Professional Staff Report
January 4, 2016

389 N. Lakeshore Drive
Geoff and Megan Hoffmann

Proposed Conditional Use Permit: Accessory Structures (Entry Pillars)

30" x 30" x 8'-0" stone pillars

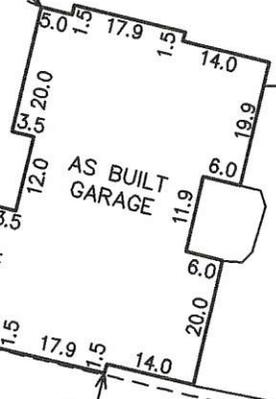
Submitted photos depict the approximate aesthetic details of the constructed entry pillars and gates.

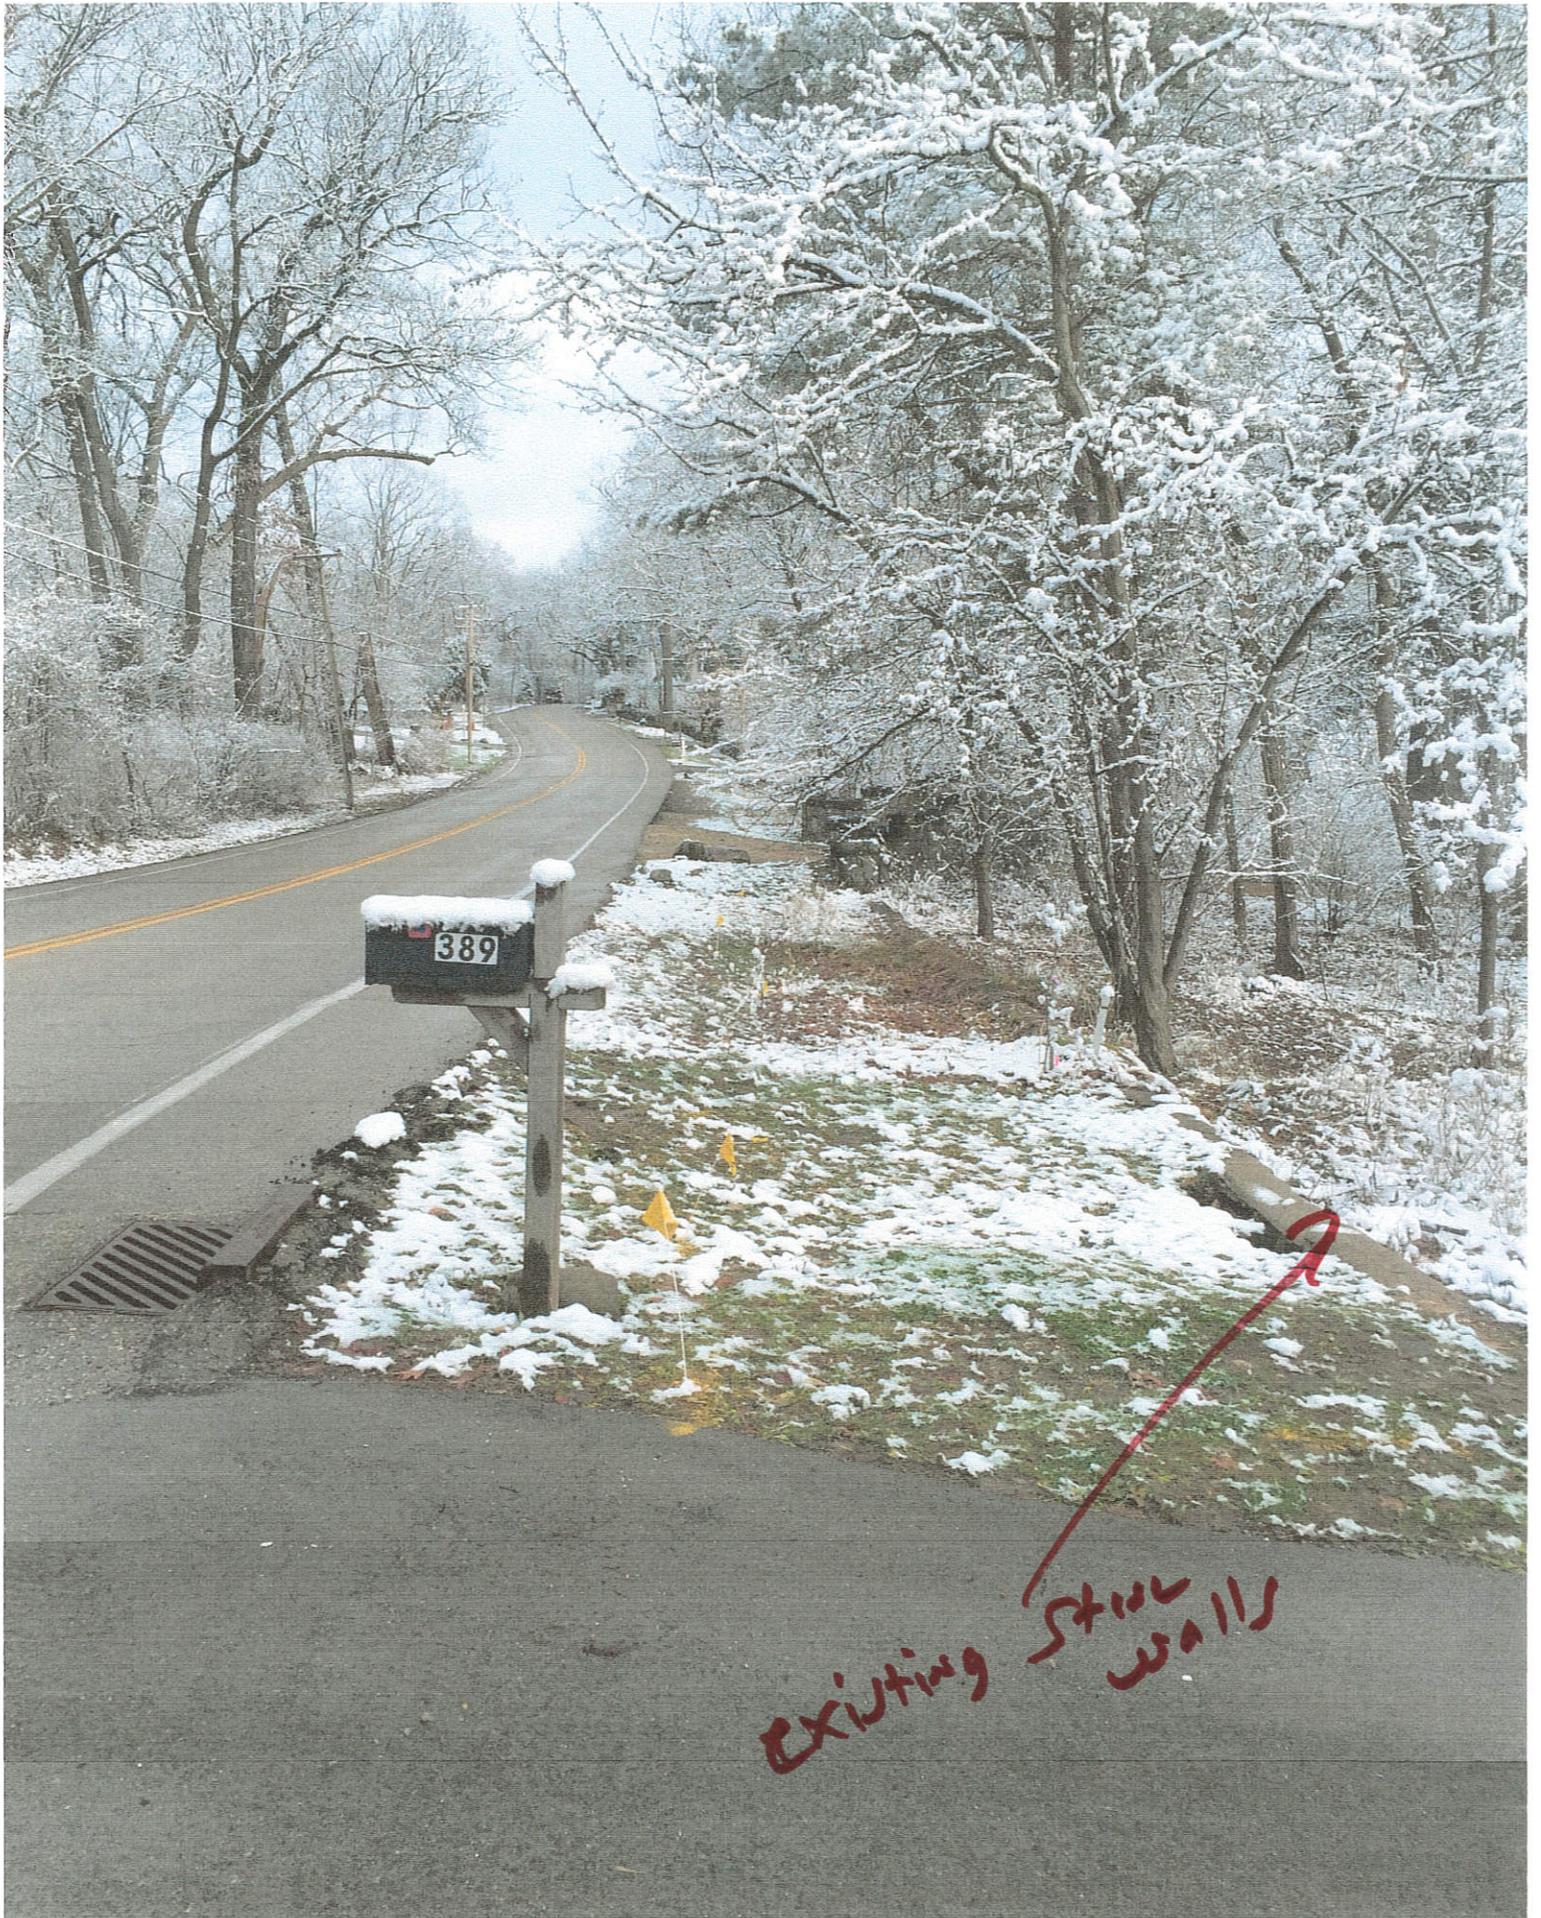
According to the submitted application, the pillars are proposed to be located 2' from the front property line. The 30"x30" pillars are proposed to be 8' in height and constructed out of stone which will match the principal dwelling unit. Outlets will be included on each pillar for lighting.

- The height of the structures (entry pillars) shall not exceed 8' as measured from existing grade.
- The pillars shall be located a minimum of 4' from the front property line or road right-of-way, whichever is closest to the primary structure, as required in Section 18-166(c) of the Fontana Municipal Code.
- Building, electric & zoning permits shall be completed, submitted, and paid for in full within ten (10) days of the date of this approval.
- All outstanding cost recovery fees billed to date applicable to this project shall be paid prior to the issuance of any building & zoning permits. This condition does not alleviate the applicant from any cost recovery fees not yet billed.
- An as-built survey shall be required depicting the location and height of the completed pillars.
